# Public Service Company of Colorado

August 20, 1979  
Fort St. Vrain  
Unit No. 1  
P-79181

Docket No. 50-267

Subject: Fluctuation Testing  
Reference: P-79094  
P-79131

FIG. 1. REQUIRED MARGIN ON ALLOWABLE MISMATCH  
(L.C.O. 4.1.7 LIMIT - TEXT)

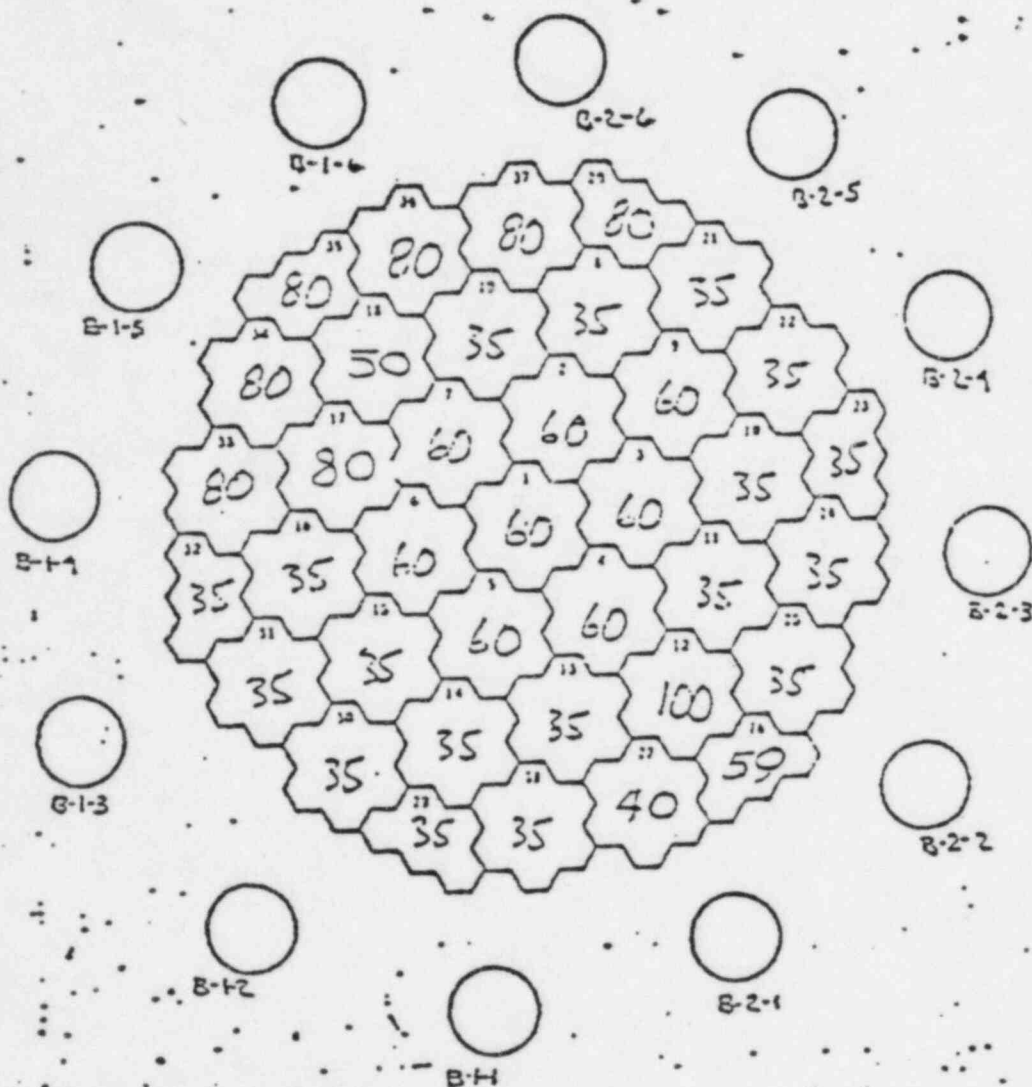
Under Operating Considerations (Sheets 5 and 6 of RT-500), it is not likely that the changes in region outlet temperature experienced during cycle 1 provide a good basis for the Figure 1 limits on cycle 2. Your note indicates that Figure 1 will be administratively revised based on cycle 2 experience. The staff should be consulted on changes to Figure 1 or a more general limitation should be defined in RT-500.

It was pointed out in the meeting of August 16, that Figure 1 represented our best estimate of temperature margins. These margins were necessarily based on cycle 1 as there is no other basis for the estimate. In addition the margins established, while they only represent a starting point, are necessary in order to obtain a core temperature outlet configuration that will keep us within Technical Specification limits.

It was agreed that PSC would keep the staff informed of changes to Figure 1, as well as other significant test procedure changes. PSC would intend to notify the staff of significant procedural changes or the intent to revise procedures when the summary test data is furnished (see attachment to P-79131). The summary test data will be submitted to the staff within one (1) week of completion of testing for each power level.

E NOTE: The margins per Figure 1 are based on cycle 1 experience. When fluctuations are observed in cycle 2, the regions that exhibit the largest temperature variations may be different. As differences, if any, are observed, Figure 1 will be administratively revised accordingly.
